# ANN ARBOR BUILDING BOARD OF APPEALS

## STAFF REPORT

Building Board of Appeals Request **BBA21-004** at 115 W. Liberty Ann Arbor, MI

### Plan Review

DETAILS AT NEW MASONRY OPGS

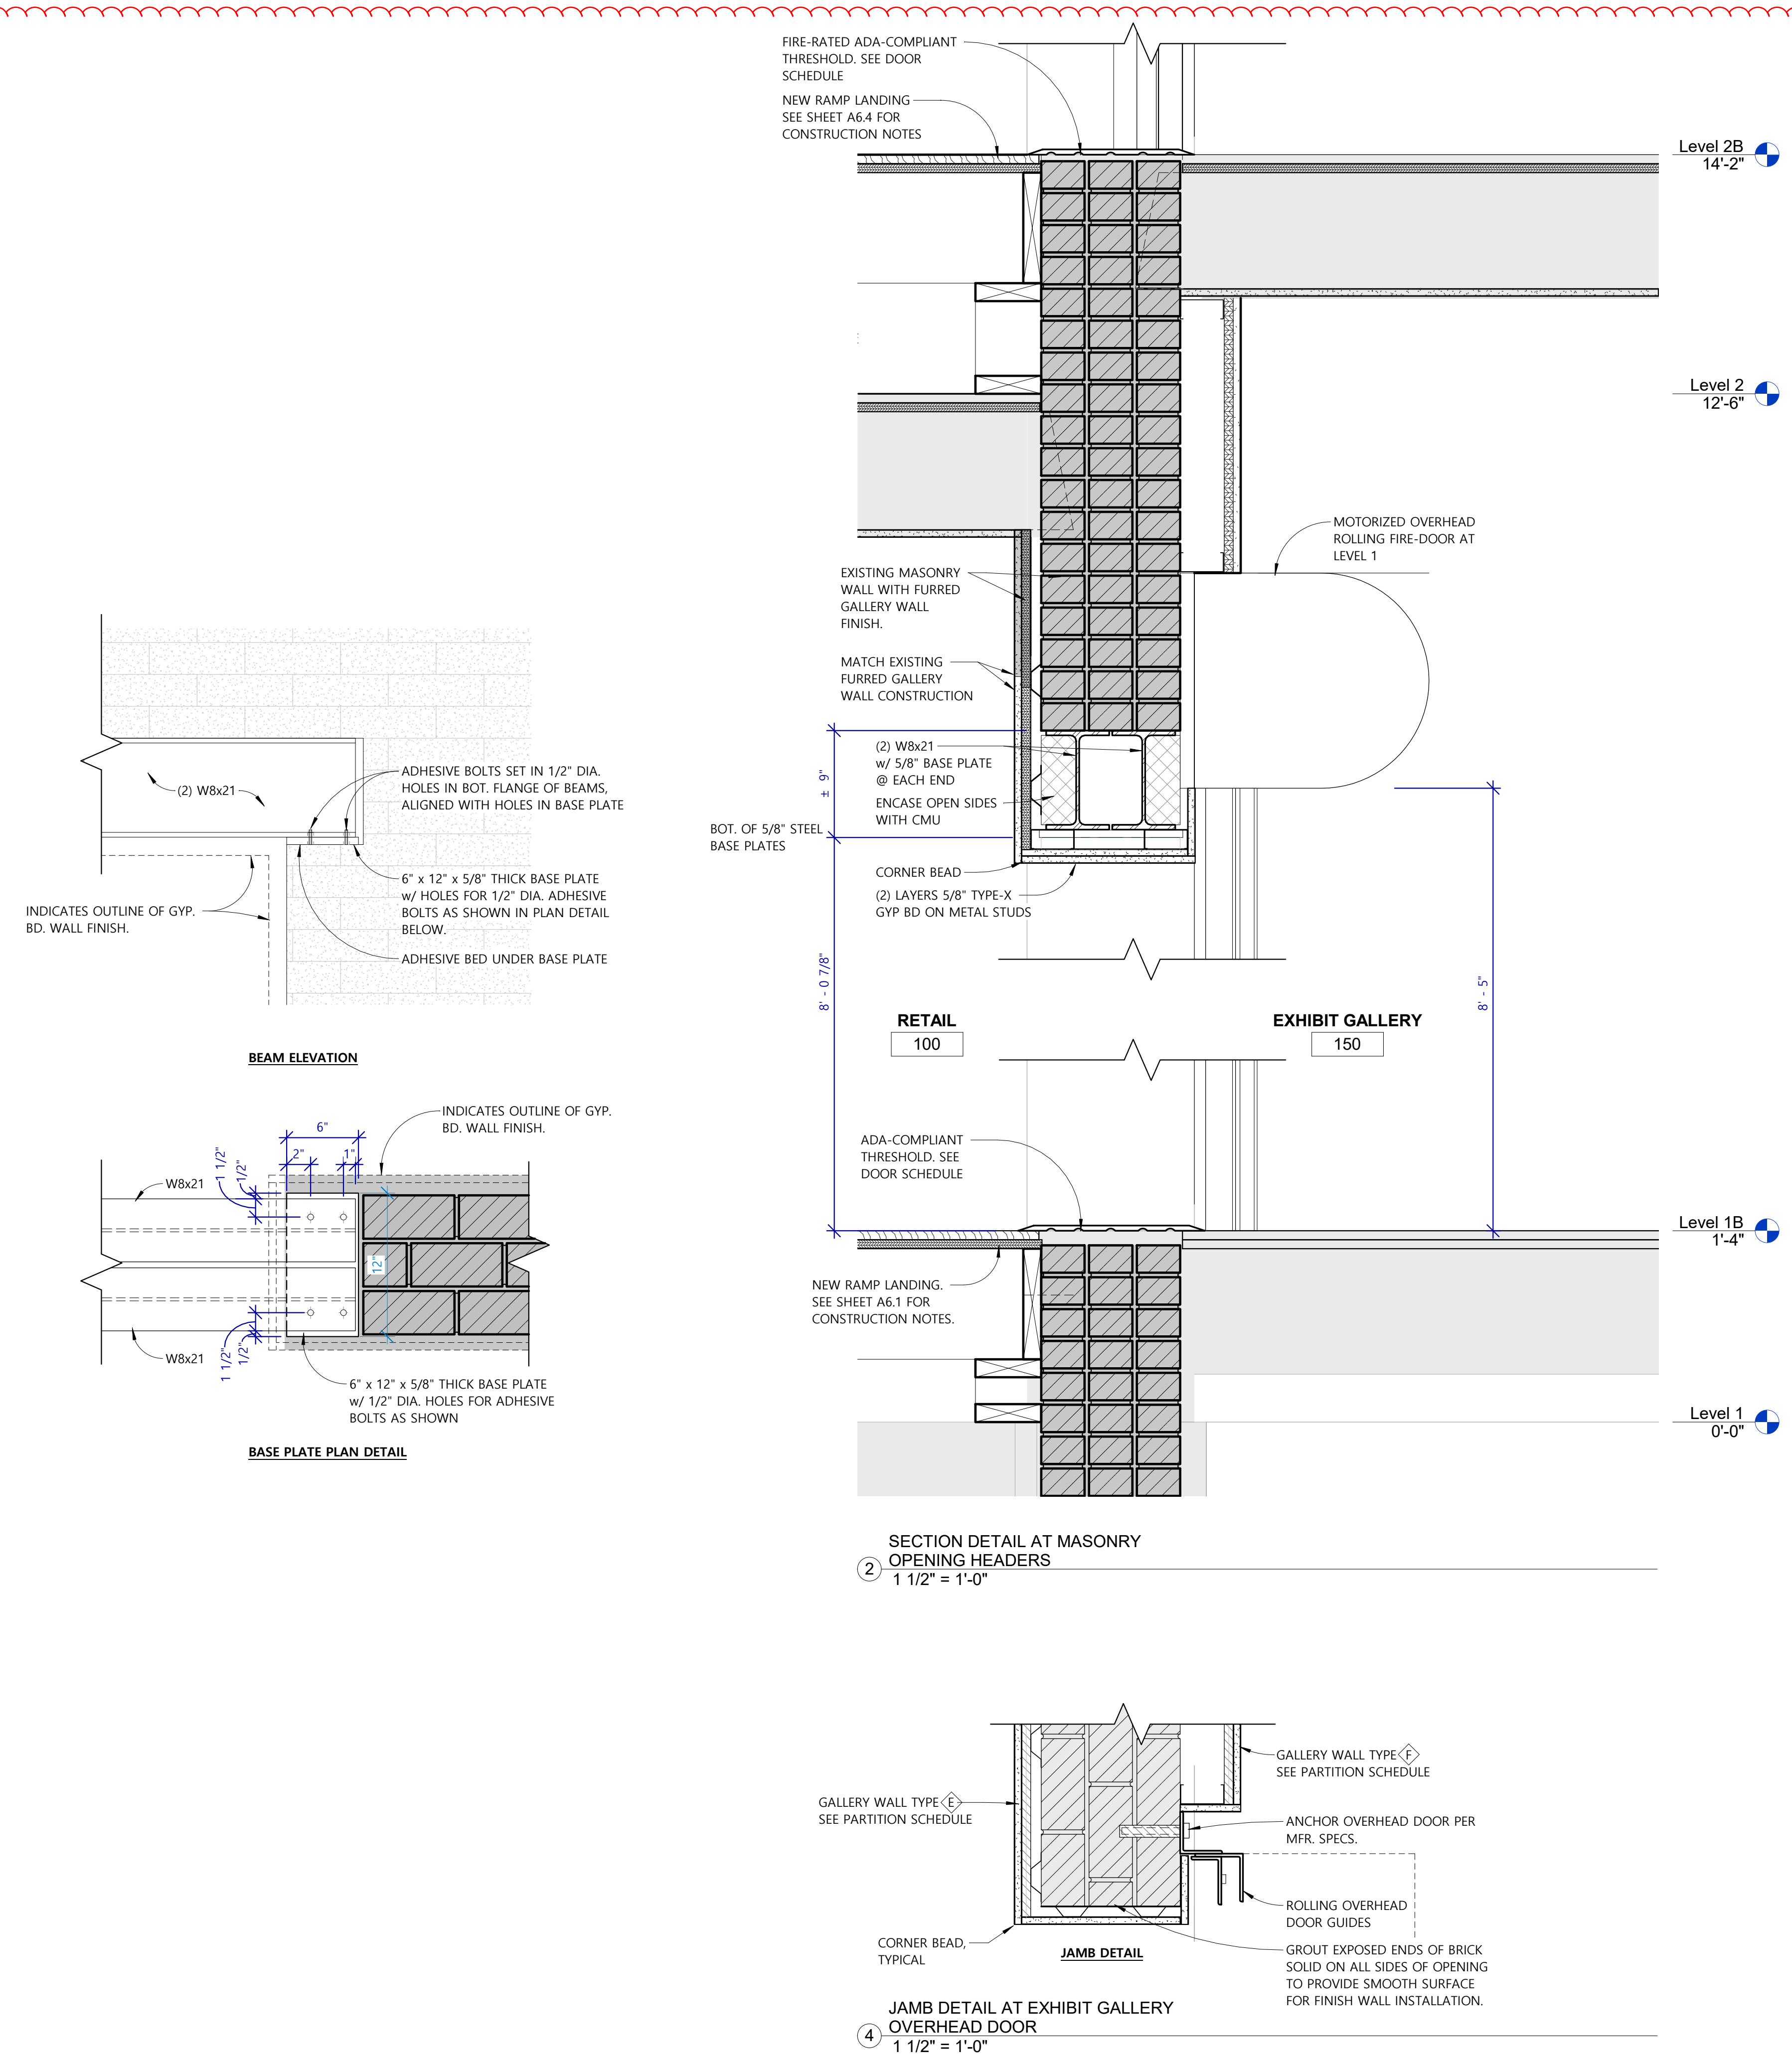
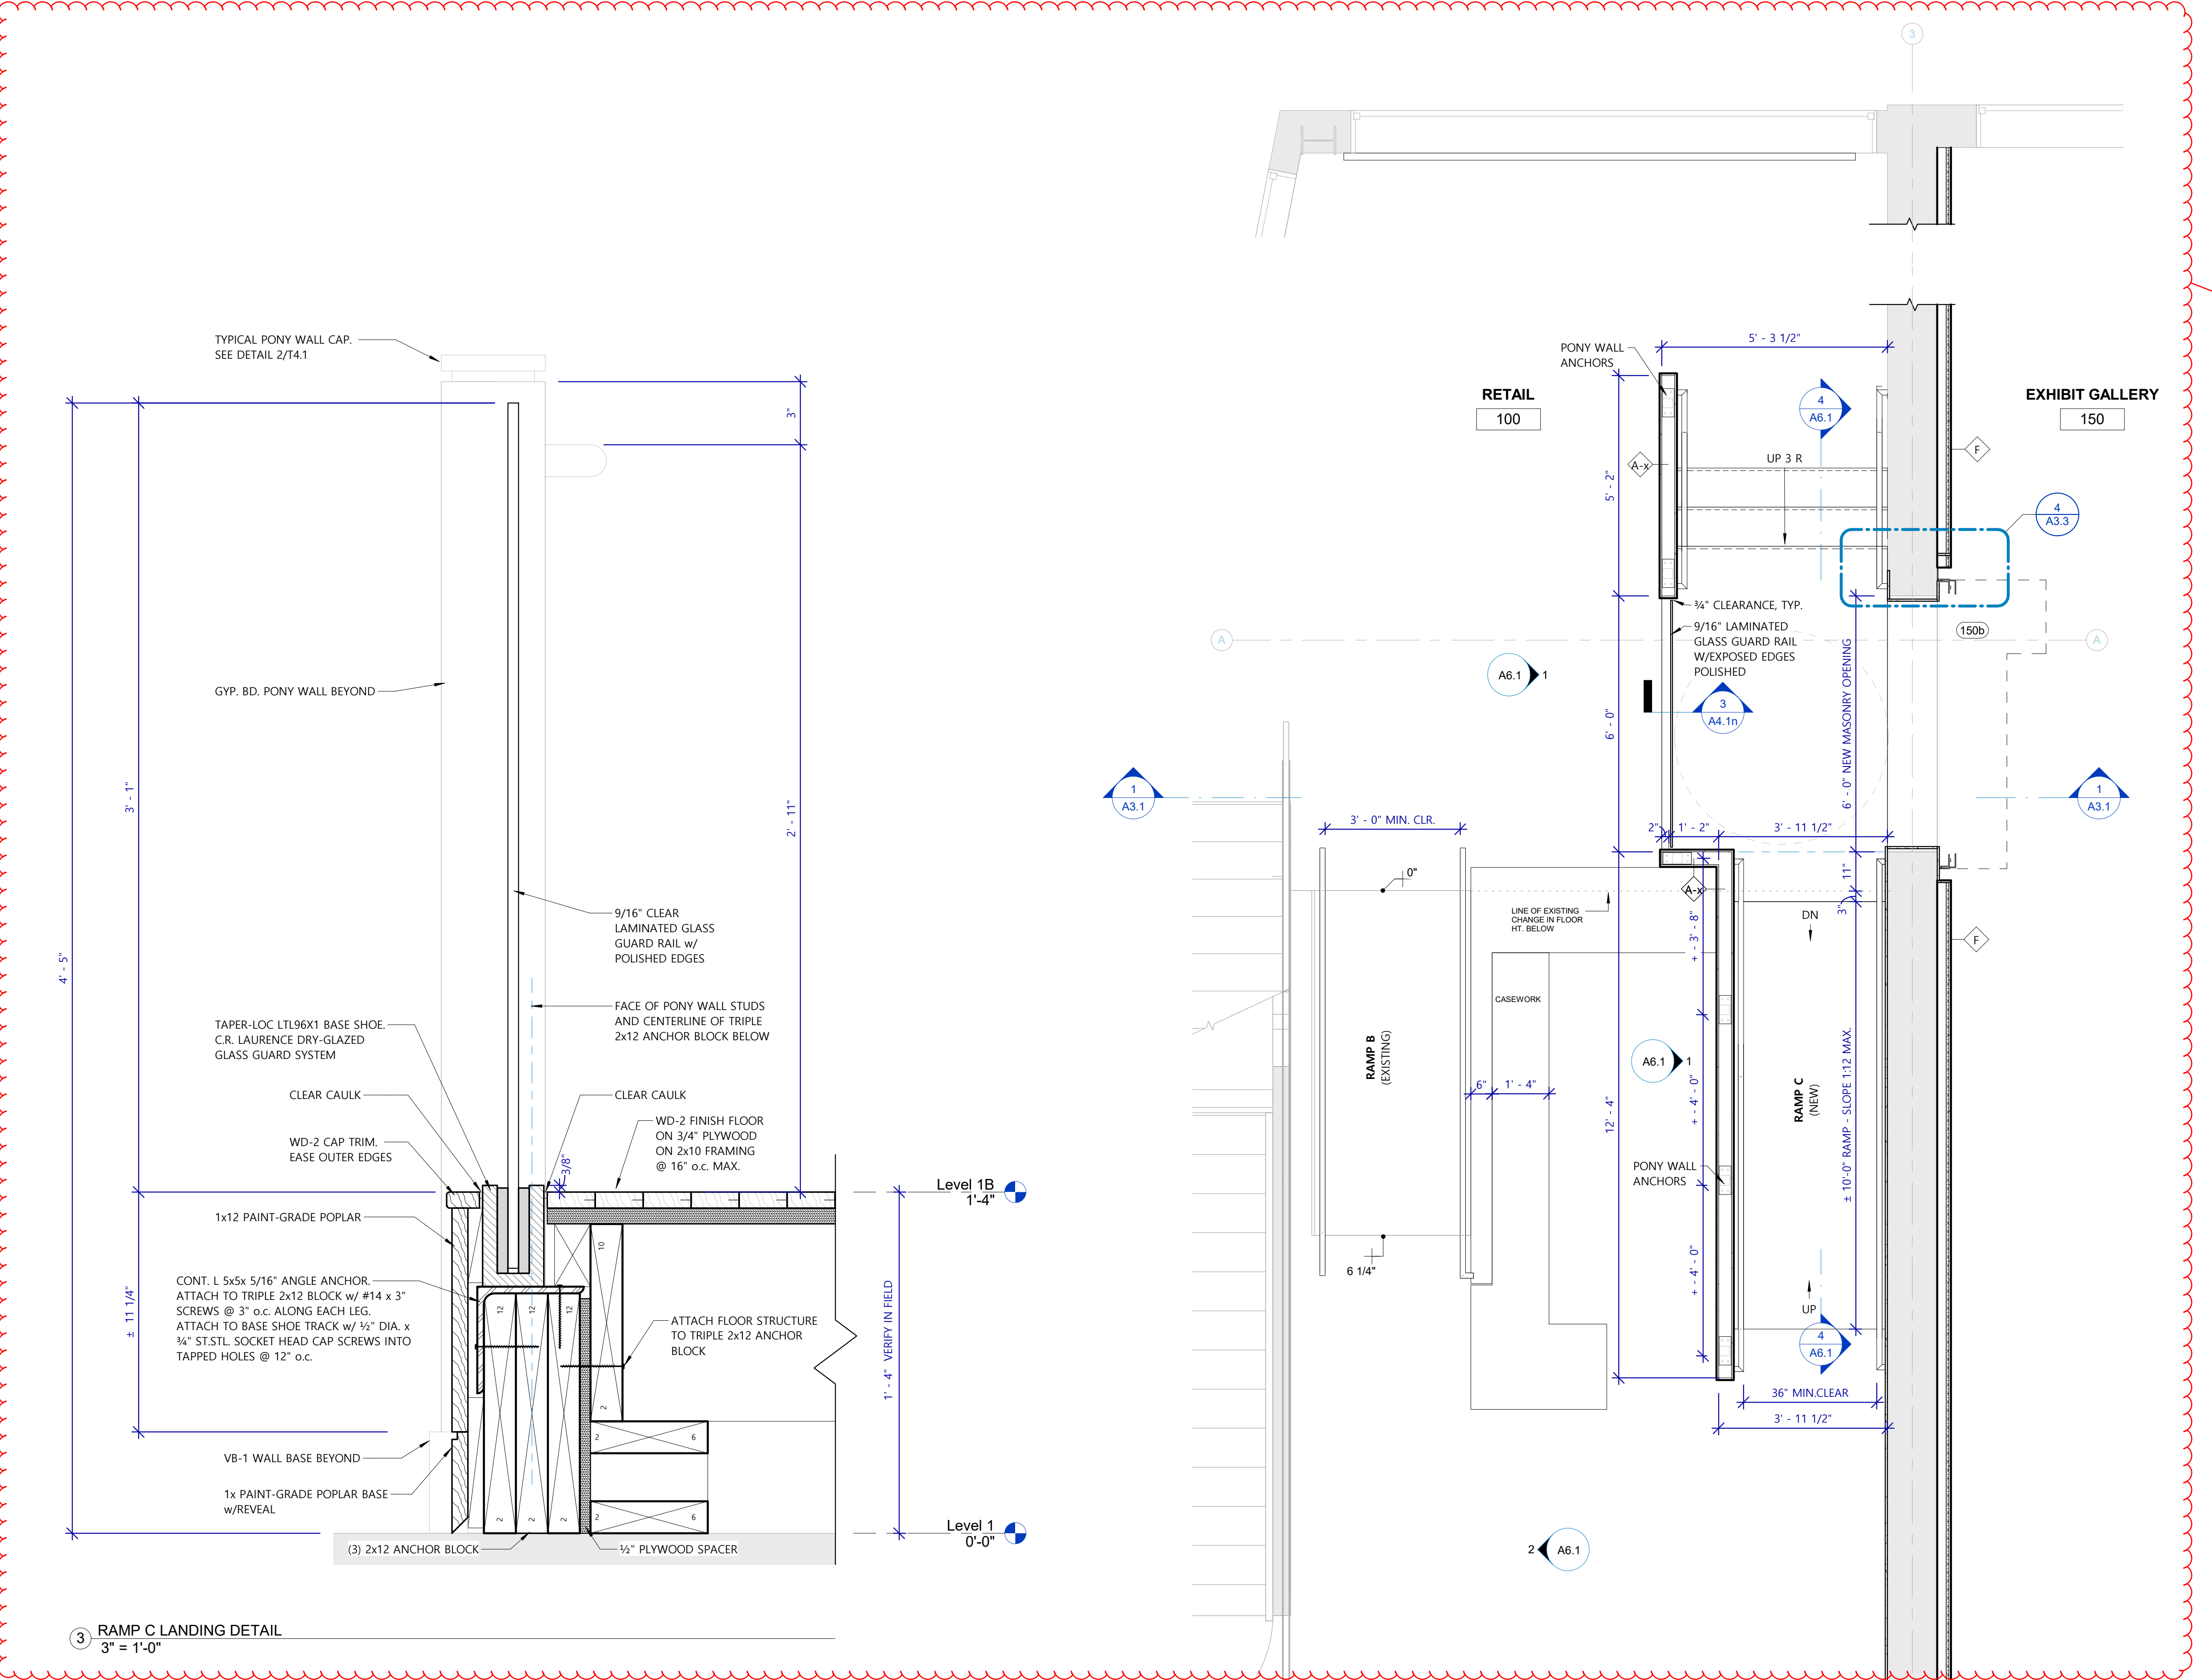
Relief from section 705, and table 705.8 allowing an opening in the fire rated wall on the first and second floor of 115/117 W. Liberty. This would allow access to the different programs and functions of both building, assist in the management and safety of the individuals attending (minors) without having to go outside to enter the other building. The first floor opening will have an alarm and sensor-activated rolling steel shutter door (3 hour rated) which will automatically close in the event of a fire. The second floor opening will have a 3- hour steel hinged door. Both openings will have a sprinkler head placed on the 117 W. Liberty side to protect the openings.

Staff does not support or oppose the appeal. The drawings submitted show the two openings between the two buildings. The deluge sprinkler system, three hour door equipped with an alarm, and the overhead 2 hour rated fire shutter with alarm could provide an equal amount of protection as the code requirements of section 705, Table 705.8 for fire separation distance less than three feet from the property line.

Our consultant, Dan Rees of Ann Arbor Fire Suppression, says that a water curtain is essentially a line of sprinklers spaced 6' o.c. max. The partial suppression system in 117 has capacity to add a sprinkler head at the proposed openings on the first and second level.

So in addition to the 3-hr-rated overhead shutter door and swing door we have already proposed, we will add (1) sprinkler head at each level on the 117-side of the openings. The first floor opening is 6' wide, so a single sprinkler head will suffice.
